ADDENDUM #3

Project Name: Renovations to the Owen J. Roberts
District Services Center

Prepared for: Owen J. Roberts School District
901 Ridge Road
Pottstown, PA 19465

Date: 08/20/2026

Switchboard Photos

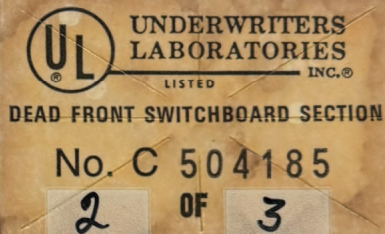
3.016 **Question:** What brand is switchboard SWA and what type breakers are required

3.027 **Question:** Reference Addendum 2, question 3.016: this states that pictures of the existing switchboard are attached to the addendum. There were no pictures attached. Please provide them.

Response: Switchboard is Siemens ITE Switchboard. Attached are some photos.

Response: *See attached to this addendum 3.*

Drawing Title:
REVISED DEMOLITION TAGS

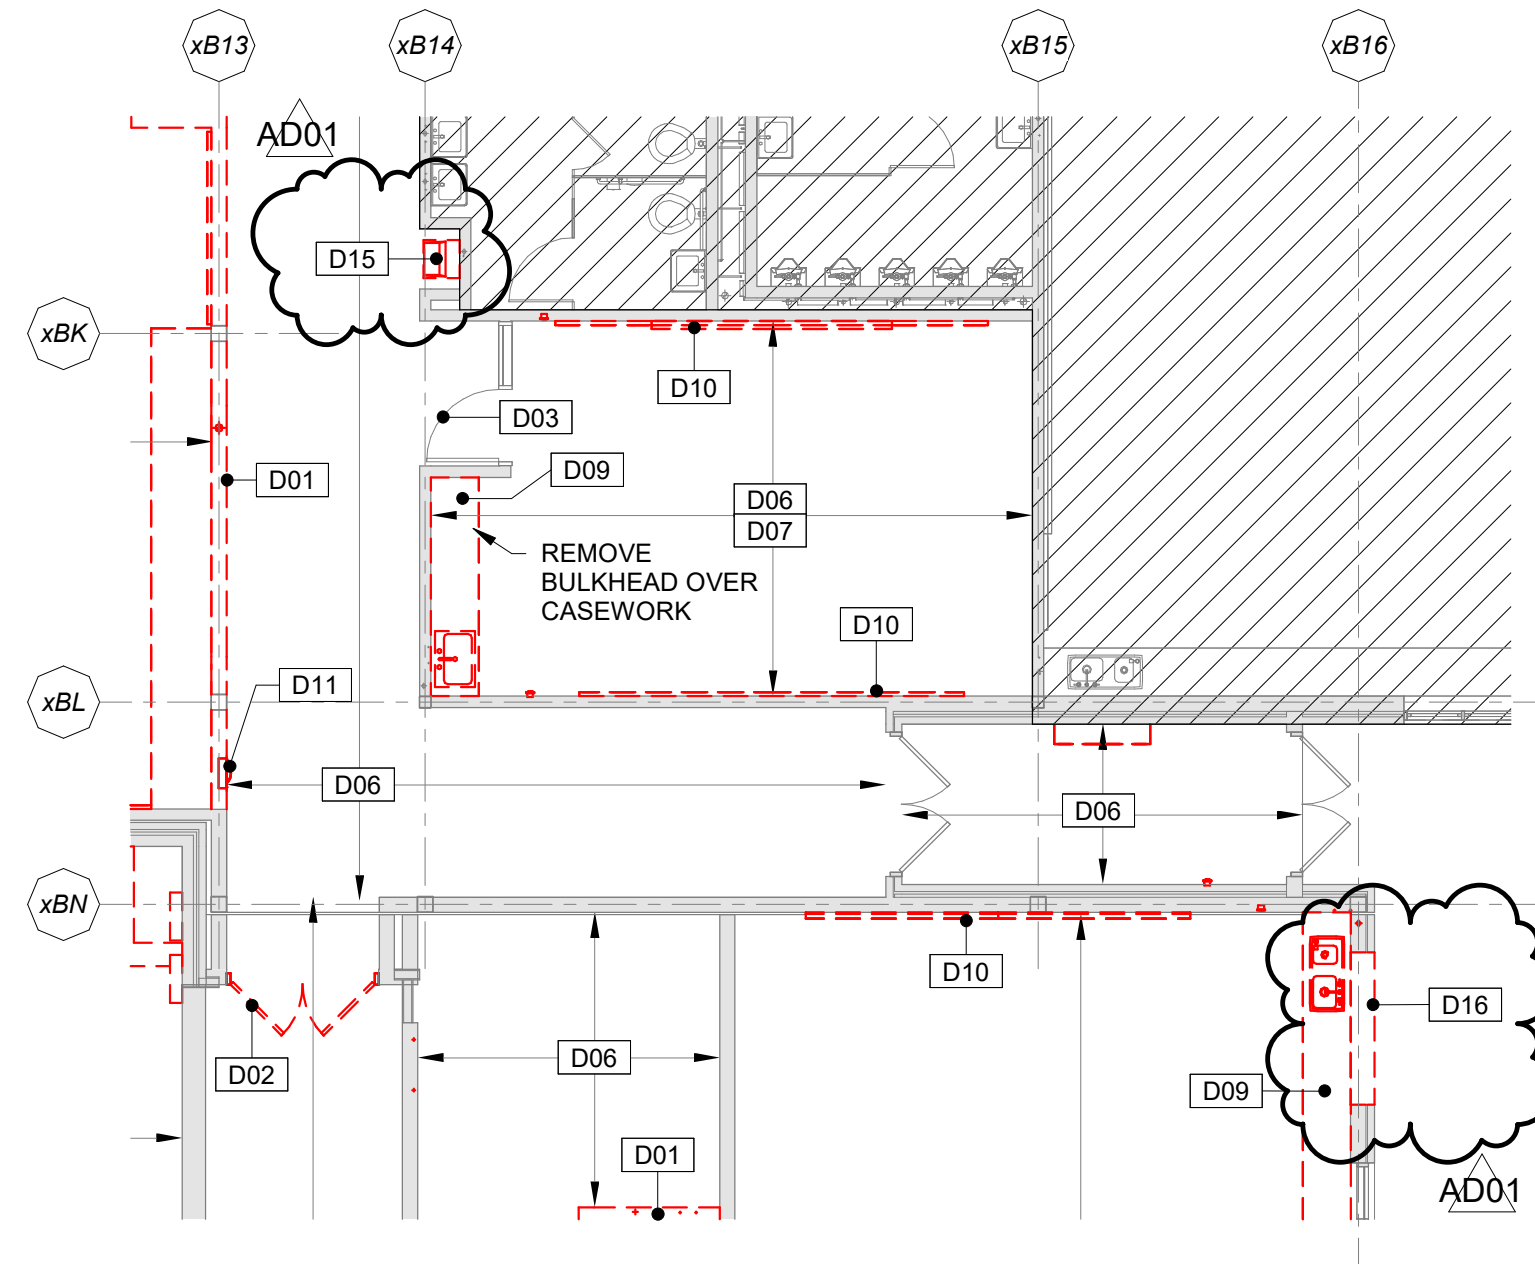
- 2.01 Drawing 1/AD101.1A: **REVISE** demolition tags as shown in the attached sketch AD3-A01.

FIRST FLOOR PLAN -
AREA A - SIGNAL

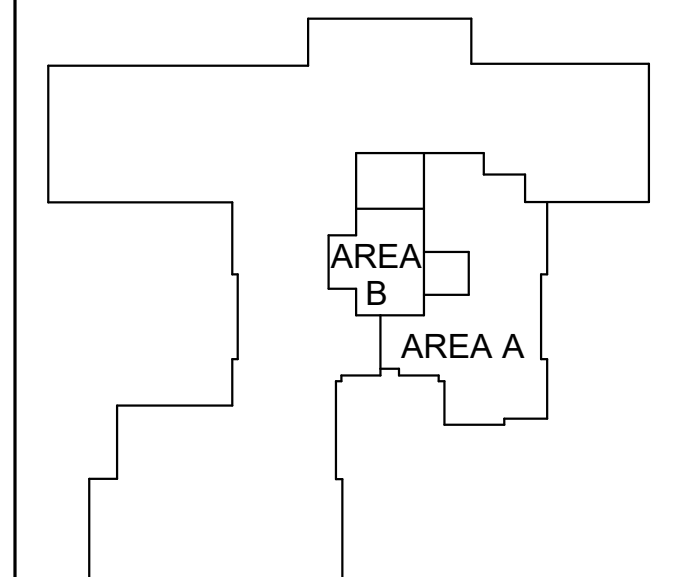
- 2.02 SED101 – SITE DEMOLITION PLAN - ELECTRICAL
- Added sheet in its entirety.
- 2.03 SE100 – SITE PLAN - LIGHTING
- Added sheet in its entirety.
- 2.04 E201.A – FIRST FLOOR PLAN – AREA A - SIGNAL
- Added information regarding card readers as per attached drawing.

- A** PROVIDE ALL LOW-VOLTAGE CABLING AND APPURTENANCES FOR A FULLY OPERABLE ACCESS CONTROL SYSTEM. REFER TO DETAIL AND SPECIFICATION FOR MORE INFORMATION.

SITE PLAN - LIGHTING

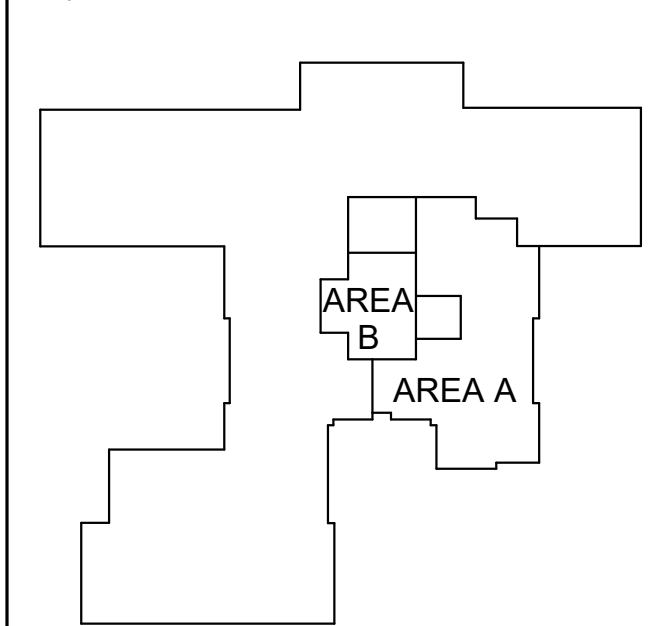
3.024 **Question:** Reference Addendum 1, Pre-Bid Agenda, section 5-h (EC Contract Scope of Work): there is a reference to "exterior parking lot lighting head replacement". This is not shown on the plans. Please verify there is no work required for replacement of parking lot lighting heads.

3.032 **Question:** Can you specify a manufacturer and how many pole lights need to be replaced for this project as per addendum #1 Electrical Construction Project Scope of Work.

Response: *Reference attachments as part of this addendum #3 for site lighting information. Only the fixture heads are to be replaced.*

Response: *Reference attachments as part of this addendum #3 for site lighting information. Only the fixture heads are to be replaced.*
